Development Review Team Comments

Project Number: PRC2021-00005

Project Name: Sherrelwood Village FDP Amendment & Filing 2 Preliminary

WC)0	D VILLAGE	SHEET TITLE
		EVELOPMENT PLAN - AMENDMENT 1	
		ER OF SECTION 28, TOWNSHIP 2 SOUTH, RANGE 68 WEST OF THE SIXTH	NARRATIVE
		COUNTY, COLORADO	SHEET NUMBER
PROJE

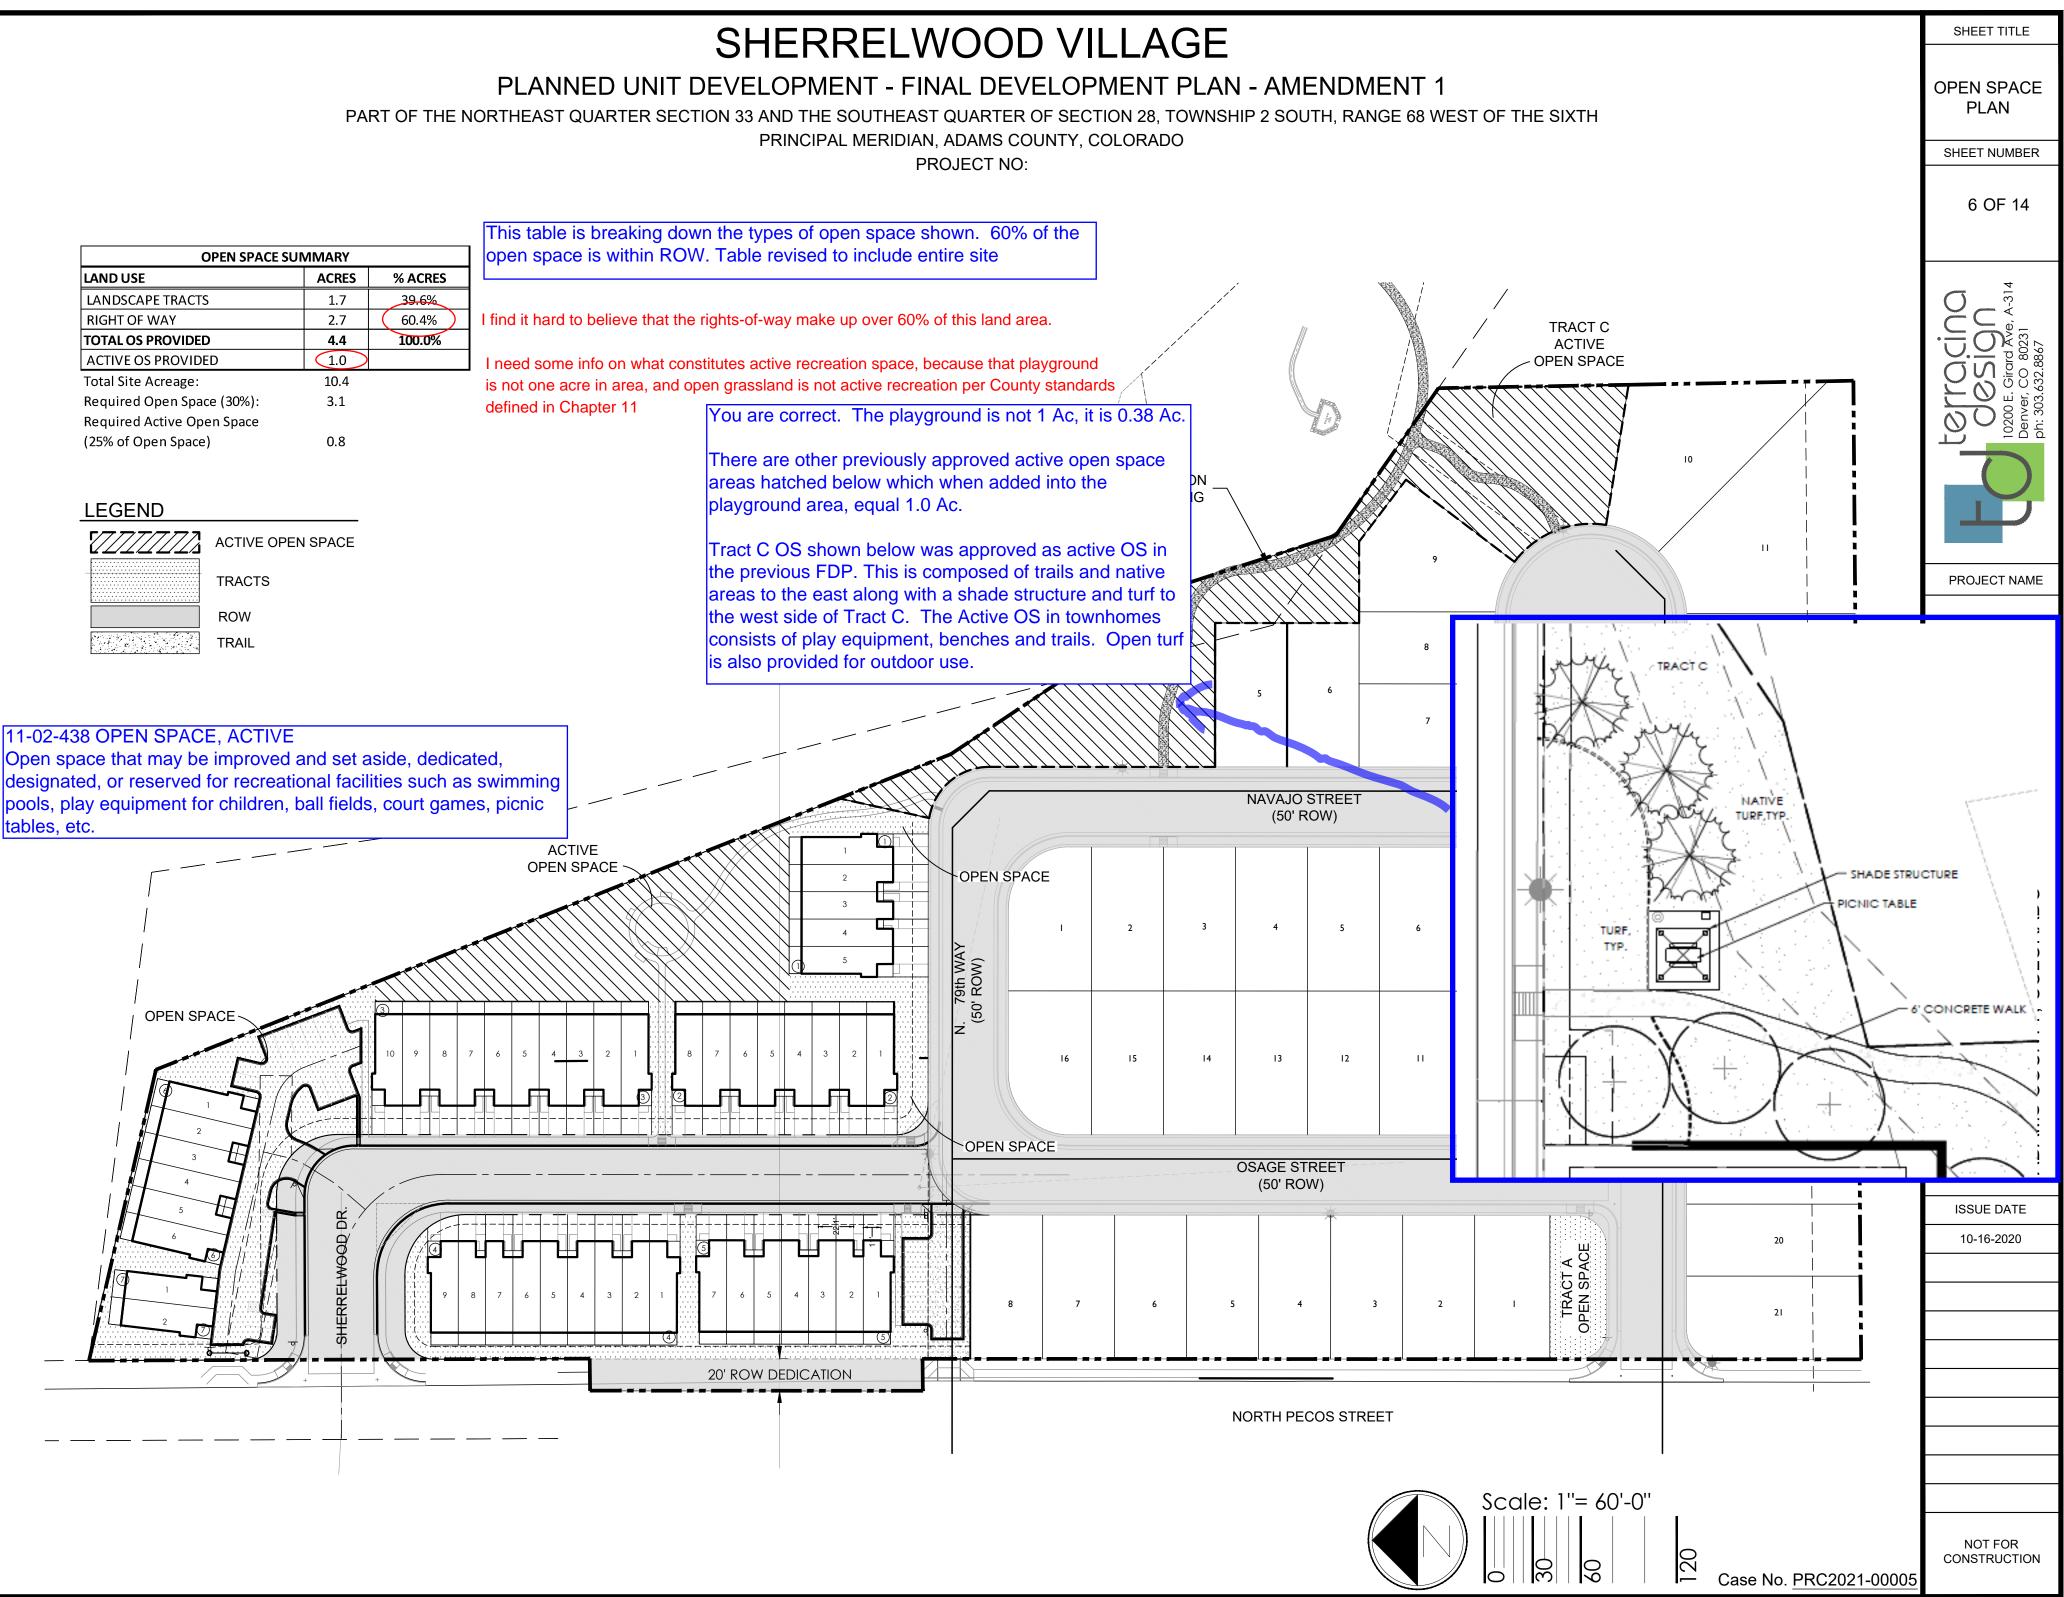
Item J is unnecessary and repetitive	4 OF 14
	J.	DESCRIPTION OF BUILDING ENVELOPES INCLUDING SQUARE FOOTAGE AND/OR MINIMUM SETBACKS, HEIGHT AND GENERAL EXTERNAL CHARACTERISTICS:	
ND AMILY R		THERE ARE 41 SINGLE FAMILY DETACHED RESIDENTIAL AND 47 TOWNHOME UNITS IN THIS PDP. SETBACKS, BUILDING HEIGHT AND SQUARE FOOTAGES SHALL BE CONSISTENT WITH THE DEVELOPMENT STANDARDS TABLE ON SHEET 6.	
IX.	K.	COVENANTS, CONDITIONS & RESTRICTIONS TO BE IMPO from previous FDP.	
FOR A		ARCHITECTURAL AND LANDSCAPE DESIGN GUIDELINES WILL BE DEVELOPED FOR SHERRELWOOD VILLAGE THROUGH THE COVENANTS, CONDITIONS & RESTRICTIONS (CC&R'S); TO BE ADMINISTERED BY THE ESTABLISHED ASSOCIATION OR DISTRICT.	OCOCE. Girc ococe. Girc enver, CO

3	Sign permit language moved here from previous page	
)		
	>	Please remove this language. It is not allowed, and staff does not support this language in the PUD. I already made this abundantly clear on the Berkeley Shores project, and you should note this for any future project.	
		This note was from previously approved FDP. Note removed	10-16-2020
) AND			
EN AND			
S		?	
ARDS /	AND A	ALLOWANCES FOR SFH NOT EXPLICITLY LISTED IN THIS PUD SHALL FOLLOW R-1-C or R-2 ZONING	
	lan	guage added	
ANCE			
			NOT FOR CONSTRUCTION
		Case No. PRC2021-00005
